**City of Portland, Maine - Building or Use Permit Application**

Past Use: Vacant Land	Proposed Use: Amendment to new single family permit # 091249 change of square footage from 2,750 - 2115.	Permit Fee: \$30.00	Cost of Work: \$30.00	CEO District: 4
Proposed Project Description: Amendment to new single family permit # 091249 change of square footage from 2,750 - 2115.		FIRE DEPT: <input type="checkbox"/> Approved <input type="checkbox"/> Denied	INSPECTION: Use Group: R3 Type: SB IRC-2003 Signature: JWB 1/15/10	
		PEDESTRIAN ACTIVITIES DISTRICT (P.A.D.) Action: <input type="checkbox"/> Approved <input type="checkbox"/> Approved w/Conditions <input type="checkbox"/> Denied Signature: Date:

**Ann Machado - 44 Bay Street - Amended House/Site Plan #2009-0078**

ONE AND TWO FAMILY	PLAN REVIEW	CHECKLIST		
Soil type/Presumptive Load Value (Table R401.4.1)				
Component	Submitted Plan	Findings	Revisions	Date
<b>STRUCTURAL</b> Footing Dimensions/Depth (Table R403.1 & R403.1(1), Section R403.1 & R403.1.4.1)	20x10 Footings - 8" concrete wall - 4" concrete floor 16x10 Footing - 8" Frost wall (Gage)	OK		OK
Foundation Drainage, Fabric, Damp proofing (Section R405 & R406)	4" perforated pipe - 6"

RIGHT ELEVATION

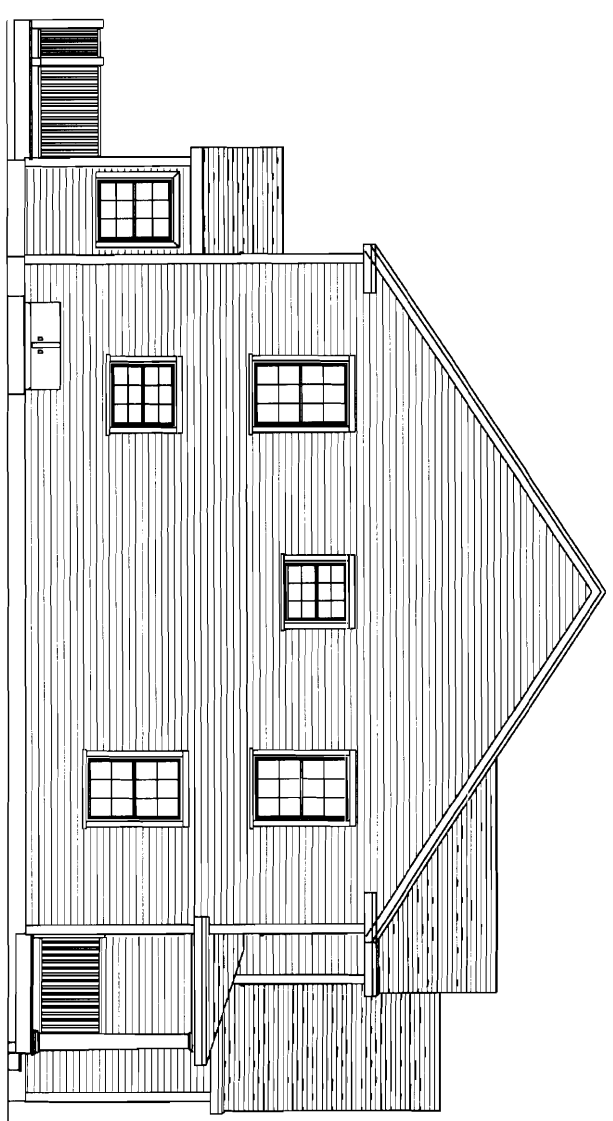
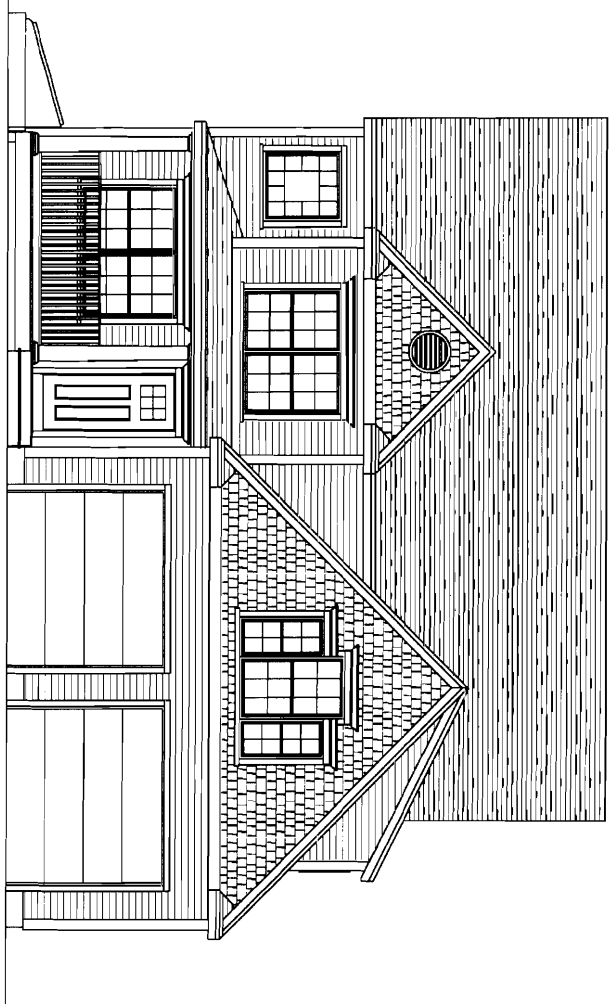
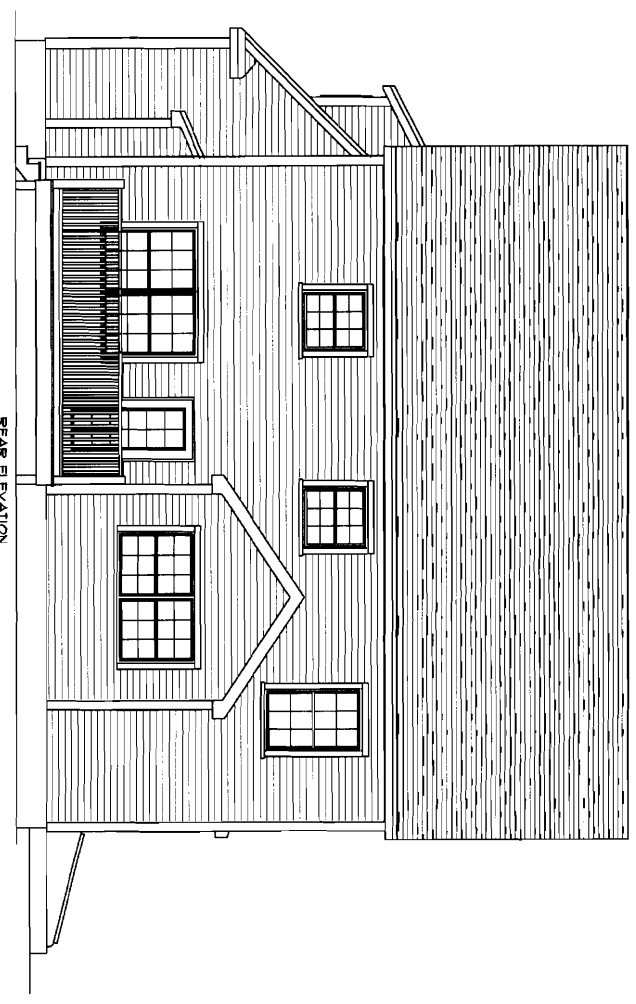
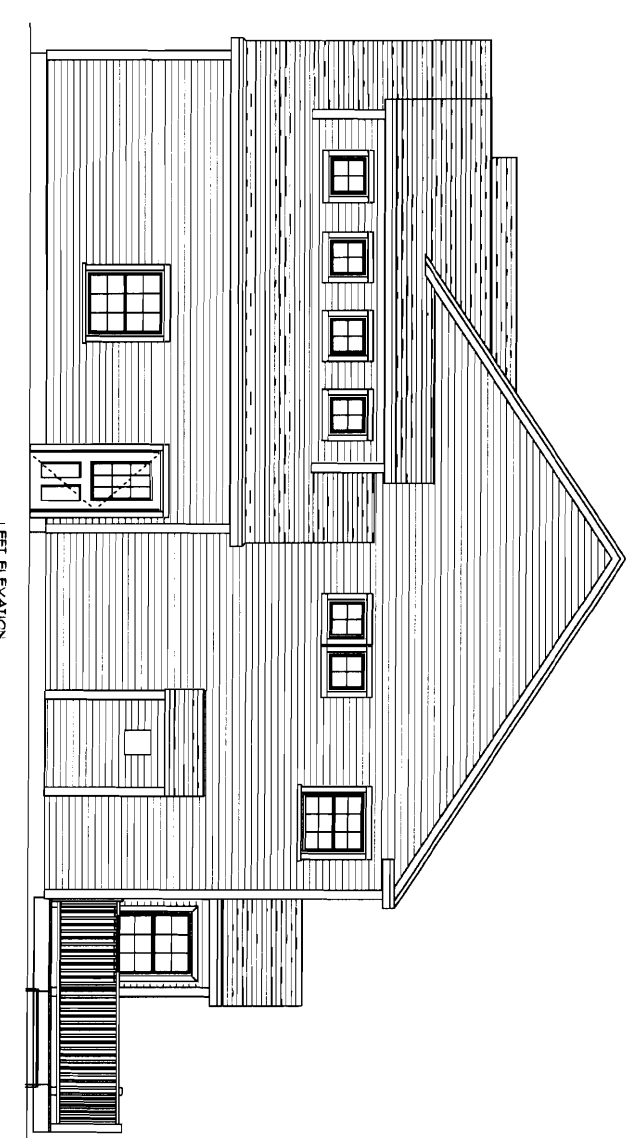
1/13/2010-jmb: Left vmsg for Jarod R. And the designer for some minor details and corrections. Tempered glazing at MB spa, no door shown at 1st fl. 1/2 bath, elevations are mirror image, baluster spacing stated at min. 4", should be < 4". Both Mike and Peter P. Called to verify the items and will email pdfs.

NO Door shown into 1st FL 1/2 bath  
Elevations are mirrored

1/15/2010-jmb: Pete emailed a better scaled version, ok to issue.
